Subject: Addendum #2

REFERENCE: B 024-23 SUBSTATION POWER TRANSFORMER FIELD SERVICE

This Addendum forms part of the contract and clarifies, corrects or modifies the original bid document. Brownsville PUB needs an additional work at the Filter Plant Substation, see scope of service attached.

SCOPE OF SERVICES - FILTER PLANT

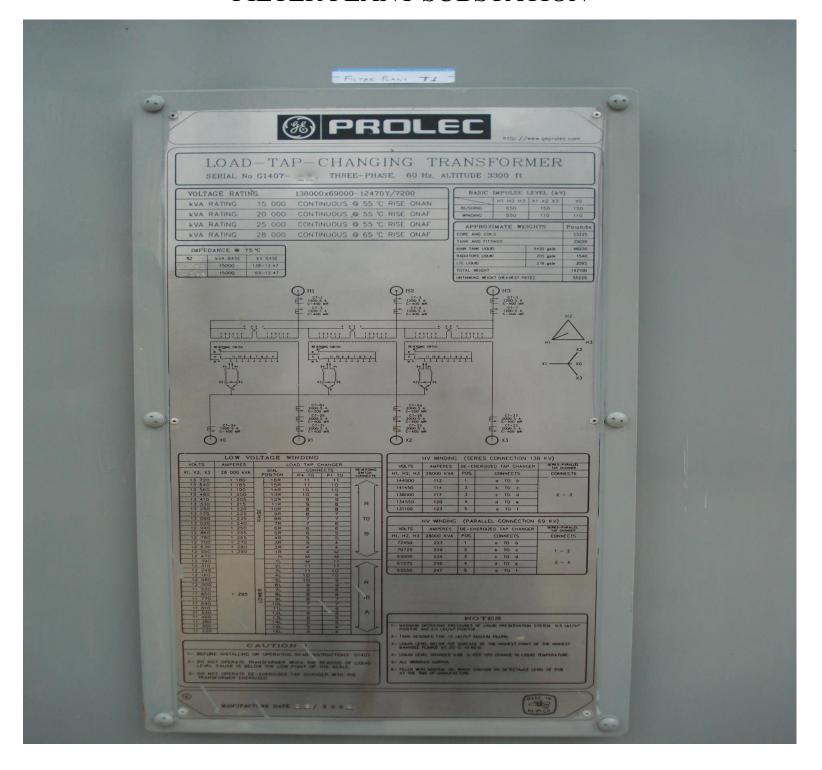
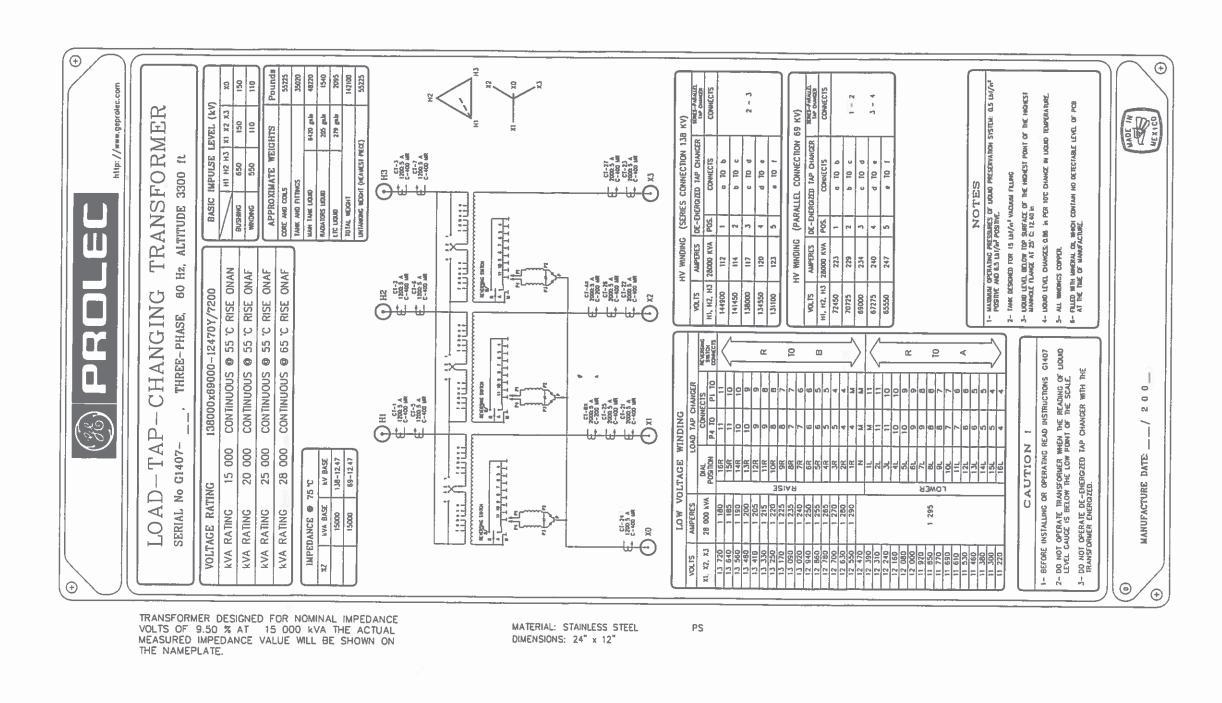
To replace gaskets for one 25 KV bushing (X0) on a 138 – 12.47/7.2 KV transformer at Filter Plant Substation, located at 1495 Robinhood Dr, Brownsville, TX. 78521.

Bushing info: Serial #: 1ZUA7C10696001; Manufacturer: ABB; Type: O+C; Rated KV: 25 KV; Rated Amps: 2000 amps; BIL: 150 KV.

Transformer Info: Manufacturer: GE-Prolec; Voltage Rating: 138x69 – 12.47/7.2 KV.

Perform electrical tests on the transformer after work is done (Doble, Excitation Current, TTR, Bushings C1 & C2 (High and Low side)).
